# Executive Director's Recommendation

Commission Meeting: July 6, 2023

<b>PROJECT</b> <b>National 9-11 Pentagon Memorial Visitor Education Center</b> Arlington National Cemetery Arlington, Virginia	<b>NCPC FILE NUMBER</b> 8472
	<b>NCPC MAP FILE NUMBER</b> 1.61(73.10)45690
<b>SUBMITTED BY</b> Arlington National Cemetery Pentagon 9-11 Memorial Foundation	<b>APPLICANT'S REQUEST</b> Approval of comments on concept plans
<b>REVIEW AUTHORITY</b> Federal Projects in the Environs per 40 U.S.C. § 8722(b)(1)	<b>PROPOSED ACTION</b> Approve comments on concept plans
	<b>ACTION ITEM TYPE</b> Staff Presentation

# Proposed Plan

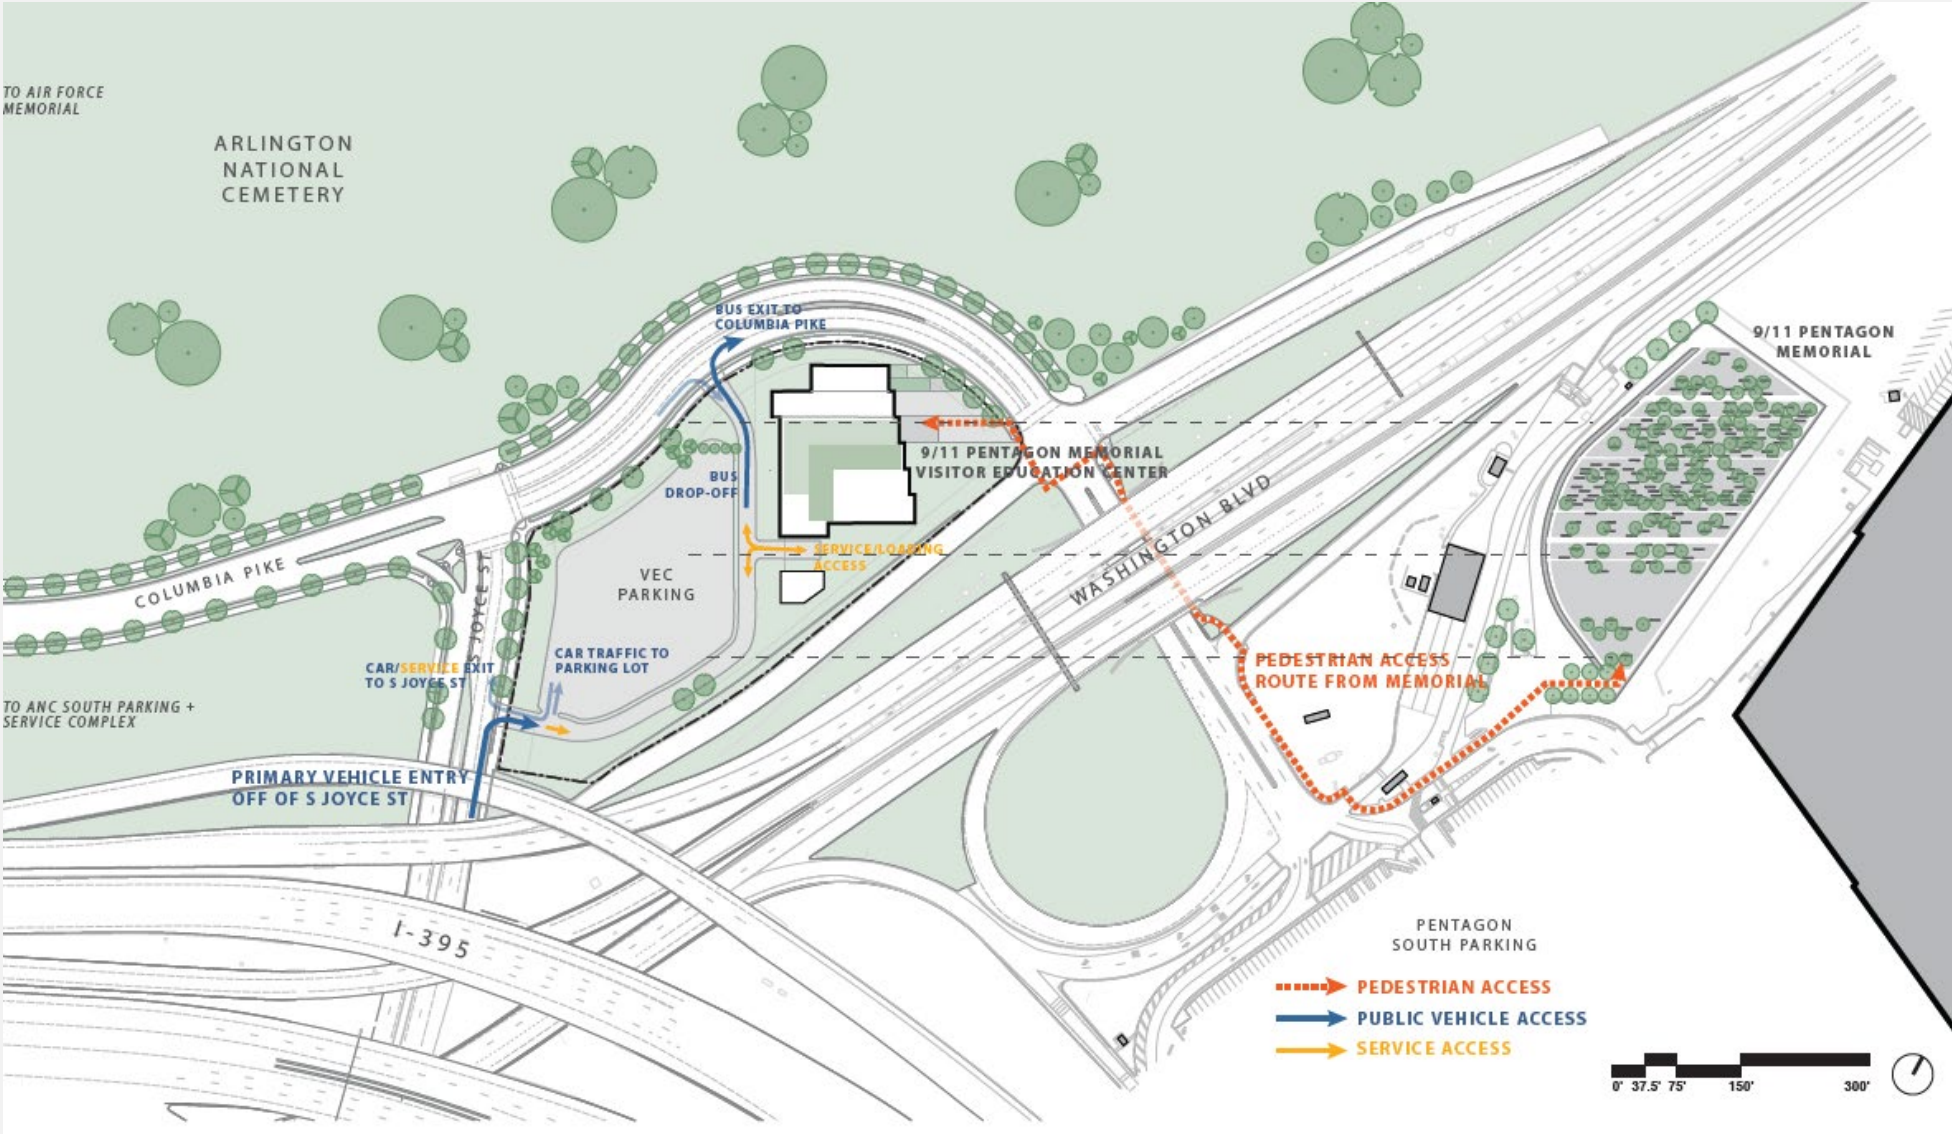
**Recommends** the applicant continue to minimize the parking areas and differentiate these spaces, especially the areas dedicated to the visitor experience which are currently designed as part of the parking lot with no connection to the building and building yard.

**Notes** that the applicant has modified the overall design of the site and reduced the number of parking spaces since early staff coordination, however the 100 parking spaces are still the dominant use of the site.

**Requests** the applicant submit the rationale for the amount of visitor parking, differentiating between spaces for the museum and spaces for the conference rooms.

# Building Design Progression

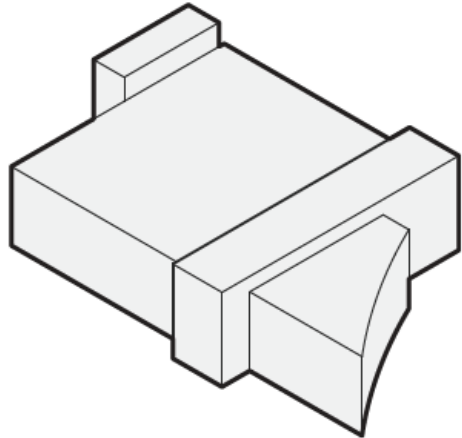
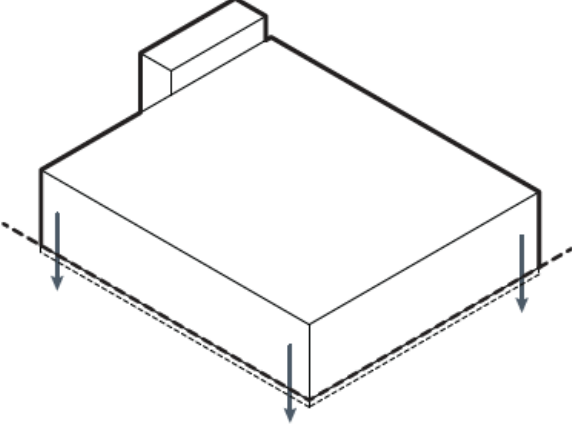
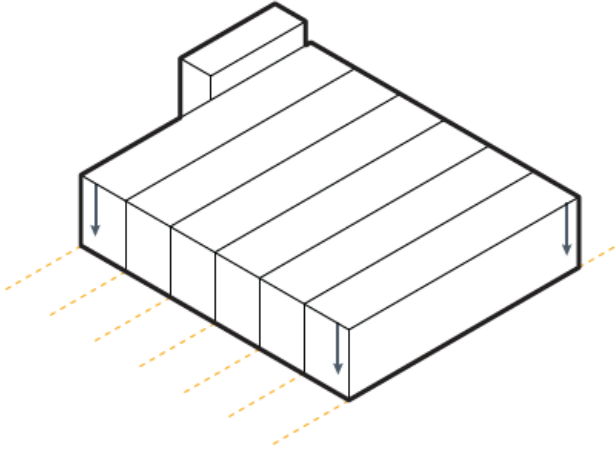
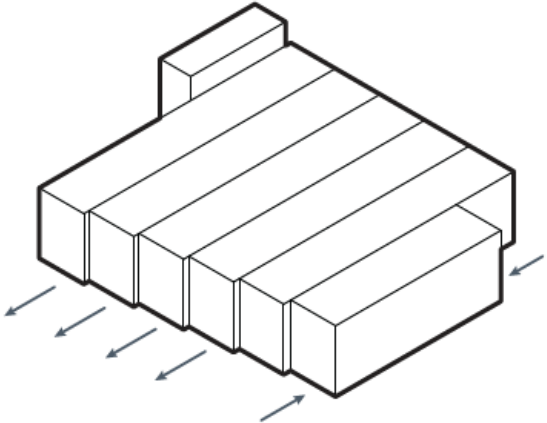
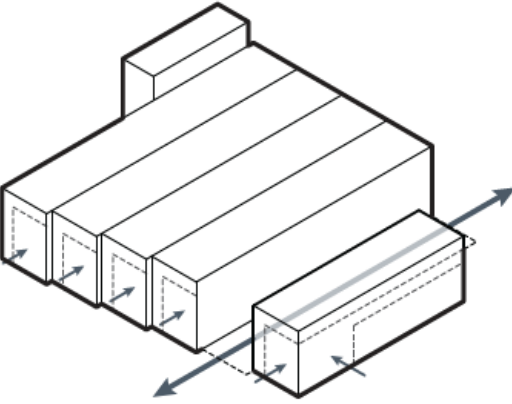
- Re-evaluate the building entry and southwest building façade, with a focus on creating a sense of hierarchy and prominence that will help guide visitors.
- Consider avoiding literal design gestures, which may be inadvertently limiting and unnecessary given the purpose and setting of the museum.
- Demonstrate, through studies and renderings, how the building material palette will complement the established character of Arlington National Cemetery.
